Development Permit Panel

MINUTES

1. **DEVELOPMENT PERMIT 18-822743**
(REDMS No. 5967186 v. 4)

PROPERTY LOCATION: 6340 No. 3 Road

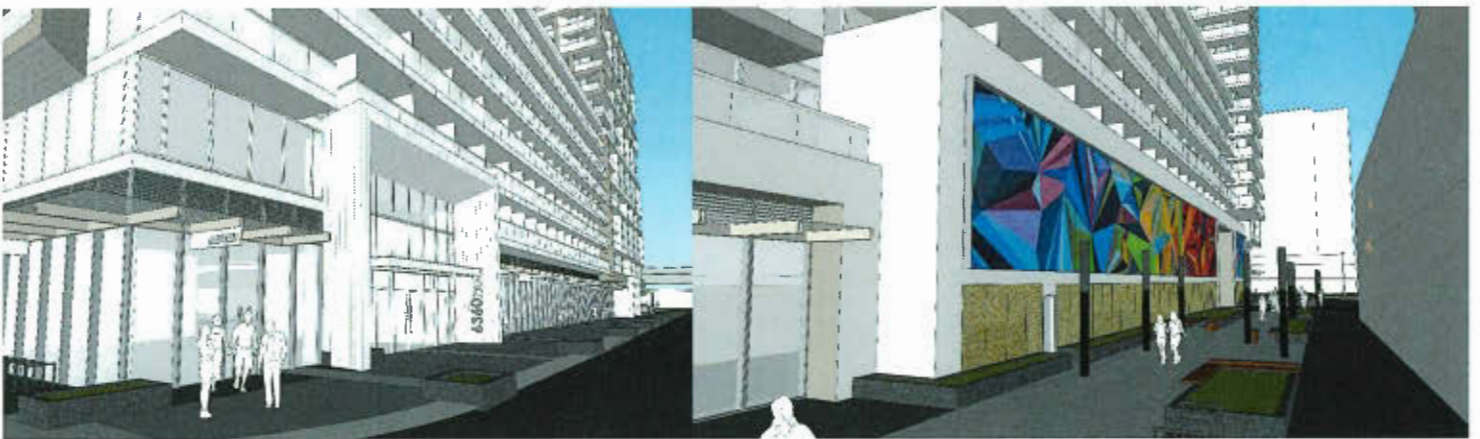
look at the venting of garbage enclosure inside the parkade; and

RESPONSE: The venting for the garbage rooms are included in the plans – Refer to A2.03;
